Re: DOCKET NO. 010789-EI

GULF POWER COMPANY 2001 DEPRECIATION STUDY DOCKET NO. 010789-EI

GULF POWER COMPANY ACCOUNT 353, TRANSMISSION - STATION EQUIPMENT

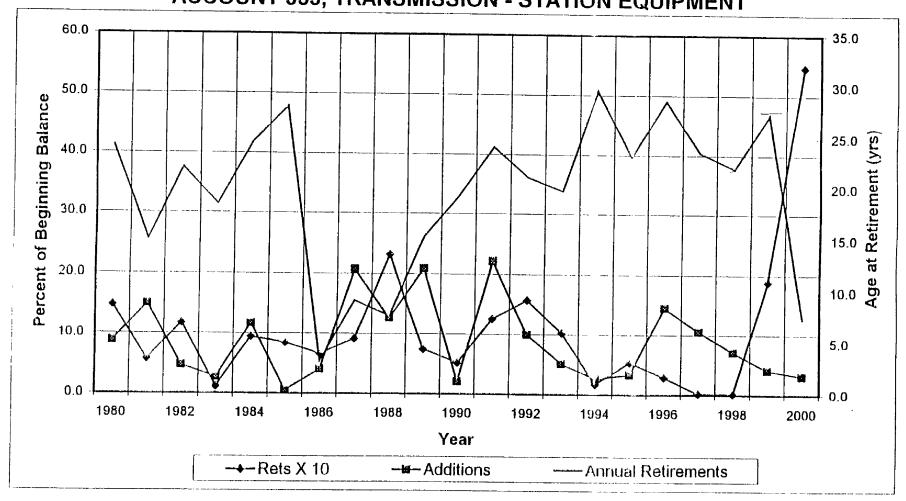
1. For those accounts that have the worksheet entitled "Additions and Retirements Ratios" (Attachment A, page 7), please provide an explanation of the source of the data shown in the various columns and its purpose. In addition, please provide the same information for the accompanying plotted chart (Attachment B, page 8).
